RE: Harnett County Land Use Application HTE 08-5-19640 Lt 2 Johnsonville Township

Matthew Leach
08-500-19640

Tract 2 (35.36 ac) Johnsonville Township

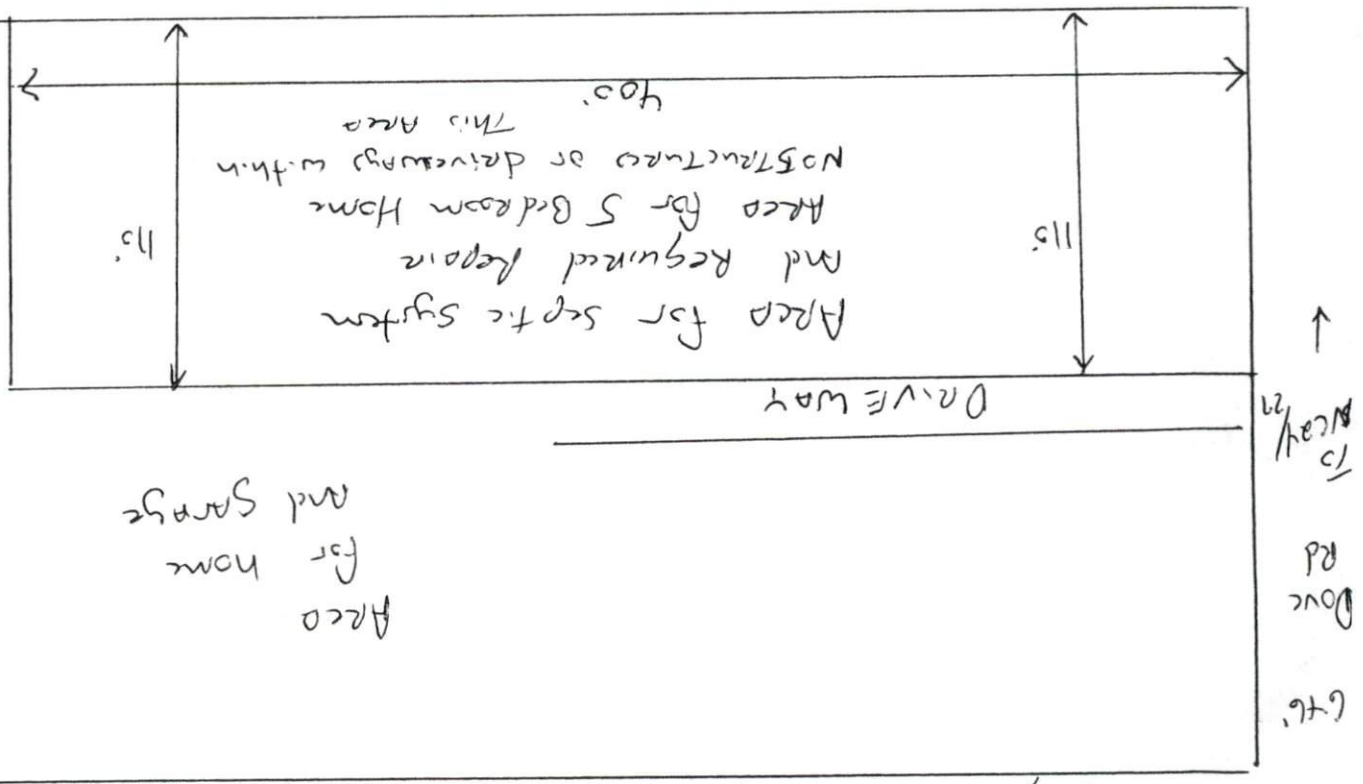
- 1. Property lines (irons)/corners not marked or labeled
- 2. House corners not marked or labeled
- 3. Directions not clear to property
- 4. Property needs brush or vegetation removed
- 5. Backhoe pits required
- 6. Other *In order to accommodate a 5 bedroom home your house site and drive must be moved out of the area shown (see attached sheet). If the number of bedrooms in the home is reduced the home may stay as is, but drive will have to be relocated. You will need to submit a new plot plan with changes to Central Permitting.*

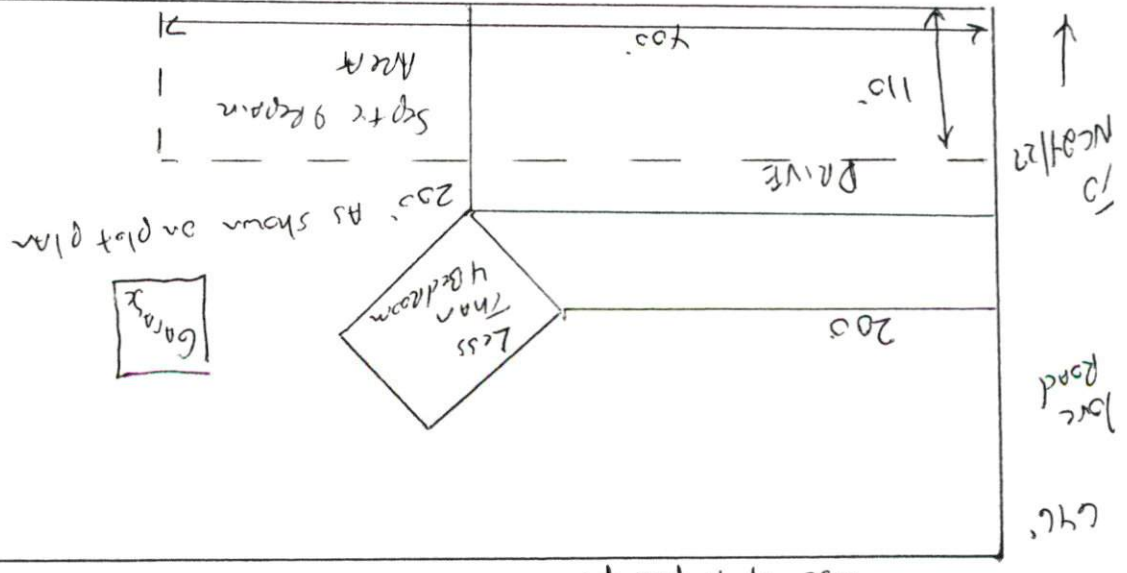
Option #1 - To accommodate a 5 bedroom home, home and driveway and garage must be moved as shown. Note septic system may require the use of a pump

Option 2 - Reduce the number of bedrooms to 3 or 4, leave home as shown on plot plan and relocate driveway and garage as shown. Note septic system may require the use of a pump.
